Access Compliance Report

Public Rights-of-Way

(Curb Ramps)

Intersection ID: 12354	Main Street: ELDRIDGE_ST	Cross Street: MORRIS_ST	Location: NW
ADA ID: E7E937E47023	Ramp Type: ParaDiag	Initial Pass/Fail: Pass	Overall Compliance: No
		Severity Score: 4

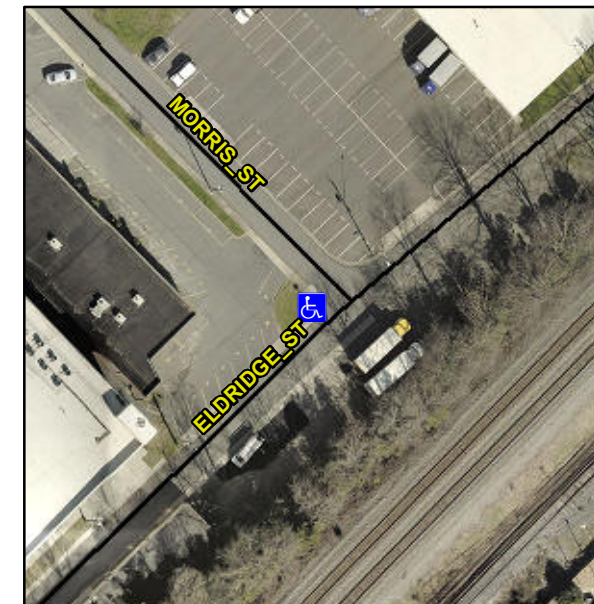
Compliance	Description	Data	Compliance	Description	Data
N/A	Ramp Length LT (in)	52.0	N/A	Ramp Length RT (in)	50.0
Yes	Ramp Width LT (in)	48.0	Yes	Ramp Width RT (in)	48.0
Yes	Ramp Slope LT (%)	7.2	Yes	Ramp Slope RT (%)	5.4
Yes	Ramp XSlope LT (%)	1.3	Yes	Ramp XSlope RT (%)	1.4
No	Landing Length (in)	45.0	Yes	DWS Provided?	Yes
No	Landing Width (in)	37.0	Yes	DWS Contrast?	Yes
No	Landing Slope (%)	3.6	Yes	DWS Length (in)	24.0
No	Landing X Slope (%)	4.9	Yes	DWS Full Width?	Yes
N/A	Landing Curb? (Y/N)	No	Yes	DWS Offset (in)	2.0
N/A	Shared Landing?	No			
Yes	Gutter Ponding?	No	Yes	Gutter Slope (%)	1.7
Yes	Gutter Lip Ht (in)	0.0	No	Gutter X Slope (%)	2.4
N/A	Painted X Walk1?	No	N/A	Painted X Walk2?	No
	X Walk 1 Direction	To S		X Walk 2 Direction	To E
N/A	X Walk 1 Width (in)	N/A	N/A	X Walk 2 Width (in)	N/A
	X Walk 1 Slope (%)	6.4		X Walk 2 Slope (%)	3.5
	X Walk 1 X Slope (%)	2.7		X Walk 2 X Slope (%)	1.0
N/A	Ramp inside XWalk1?	N/A	N/A	Ramp inside XWalk2?	N/A

Road Slope (%)	2.1	N/A	Clear Space?	Yes
	Road X Slope (%)	4.5	N/A	Clear Space to XWalk (in)	N/A
Yes	Any Obstructions?	No	Yes	Storm Grate/Utility Hazard?	No
	Obstruction Type			Storm Grate/Utility Type	
		N/A			N/A
			Yes	Surface Condition? (G/P)	Good
			Compliant	Curb Slope (%)	2.5

**Remove & Replace Landing.
Remove & Replace Gutter.**

**R304.2.1, R304.2.2-Perp, R304.3.2-
Para, R304.5.3**
